Office Action Summary

09/916,749

DETAILED ACTION

Fig. 3.

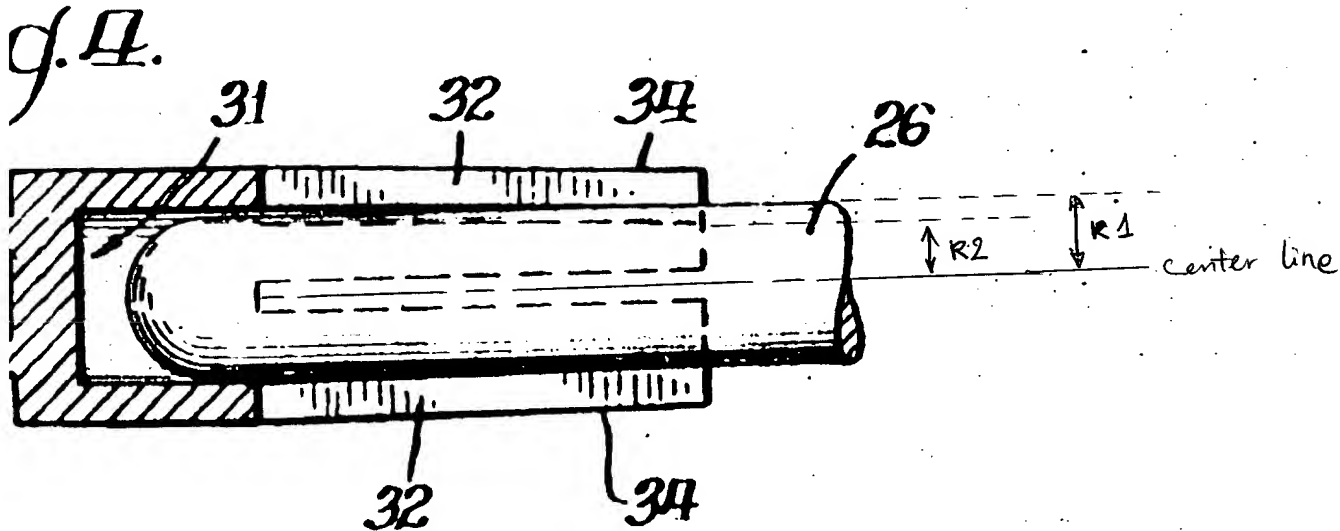
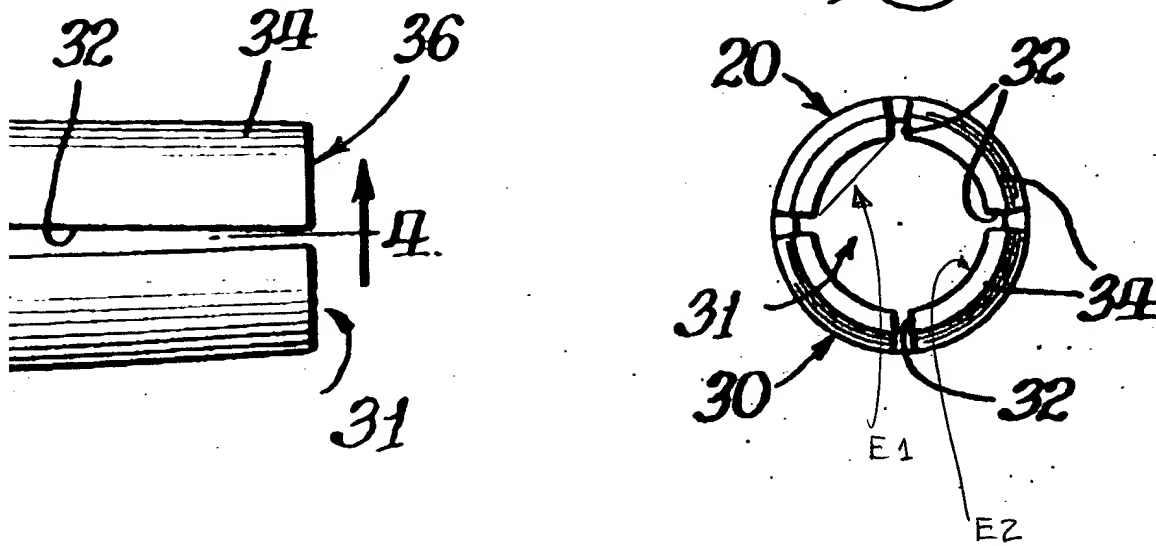
Regarding claim 2, Kehl et al. disclose an electrical contact (20) comprises:

a plurality of tines (34) providing an inner arc (E2, see Examiner's attachment) includes a radius (R2, see Examiner's attachment) that is less than the radius (R1, see Examiner's attachment) of the pin (26) , see Figure 4), wherein a chord (E1, see Examiner's attachment) across the inner art is disposed on a same side of said at least one of said plurality of tines as is said pin.
